**Project Addresses:** 306 N Brooks Street  
**Application Type:** Demolition Permit, Zoning Map Amendment, Conditional Uses, and Certified Survey Map Referral  
**Legistar File ID #** [83527](#), [83907](#), [83529](#), and [83531](#)  
**Prepared By:** Chris Wells, Planning Division  
Report includes comments from other City agencies, as noted  
**Reviewed By:** Kevin Firchow, Planning Division

**Proposal Summary:** The applicant is seeking approvals to construct 15-story, 189-unit apartment building at the northwest corner of W Johnson Street and N Brooks Street following demolition of a four-story lodging house. The underlying lots comprising the subject site will be combined into one lot by CSM. The letter of intent indicates that construction will commence in December of 2025, with completion anticipated in June of 2027.

**Image 1: Building Heights Surrounding the Subject Site. (Source: Vierbicher Associates)**

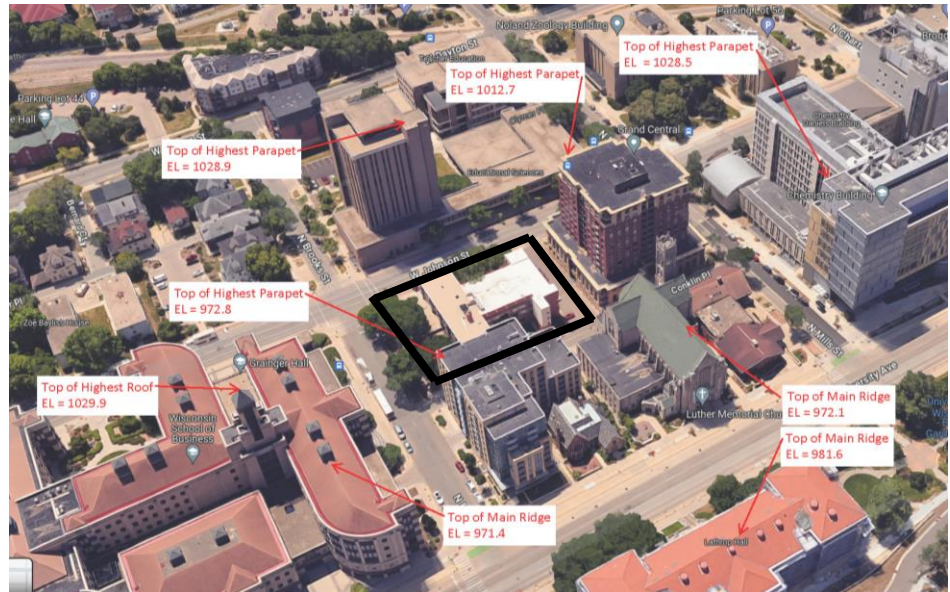
As a measure of building scale, staff have used building height as a proxy. The proposed building height is roughly 161 feet, which equates to roughly 1,032 feet above sea level. (The Capital View Preservation height limit is 187.2 feet above City datum or 1,032.8 ft above sea level). For comparison’s sake, the applicant team prepared a building height survey of the surrounding parcels (see Image 1 below).

This means that there are three buildings located in the surrounding block (four if you count the Grainger Hall spire) that rise up to at least the 1,012-foot mark (or within roughly 20 feet of the proposed building), two of which rise up to less than five feet of the proposed building. Furthermore, the proposed building’s mass and stepbacks closely resembles that of the adjacent Grand Central apartment building to the west which also has a roughly five-story base before stepping back on all sides.
